Department of Transportation

MEMORANDUM

SUBJECT: BZA Case No. 18400C – 6045 16th Street NW (Milton Gottesman Jewish Day School)

Figure 1 | Projected On-Site Queuing

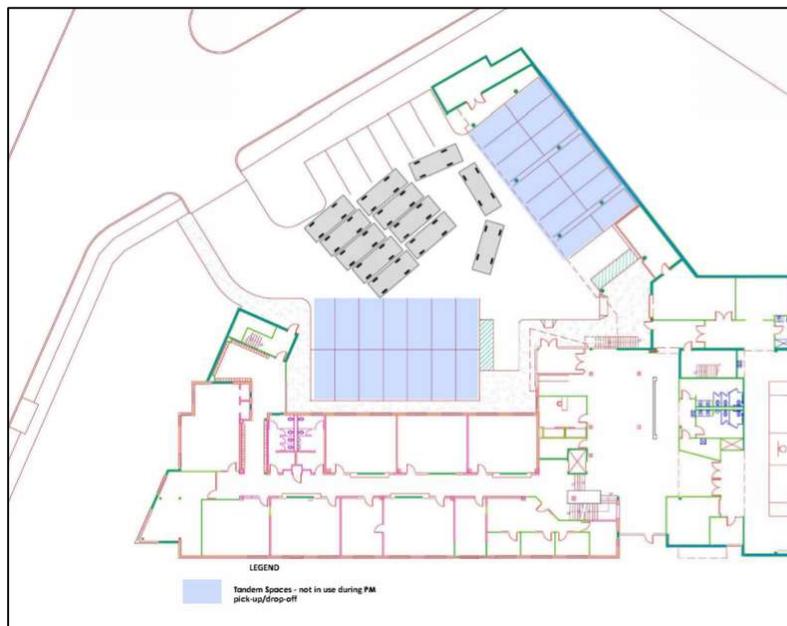
- The proposed increase in number of students and staff will increase the number of vehicles queuing for pick-up/drop-off from nine (9) to 12 vehicles, however all queuing activity can be accommodated on-site;

The Applicant proposes to continue the pick-up and drop-off plan observed as part of the 2019 performance monitoring study. Vehicles must approach the site in one direction from Fort Stevens Drive, drop off students on-site in the rear of the parking lot, and then exit via the driveway on Rock Creek Ford Road NW. The Applicant also plans to maintain the existing circulation plan where vacated, stacked parking spaces are used for on-site circulation and queuing. The proposed increase in the number of students is expected to increase the number of vehicles queuing for pick-up/drop-off from nine (9) to 12 vehicles. As shown by Figure 1 below, the proposed increase in vehicles can continue to be accommodated on the site.
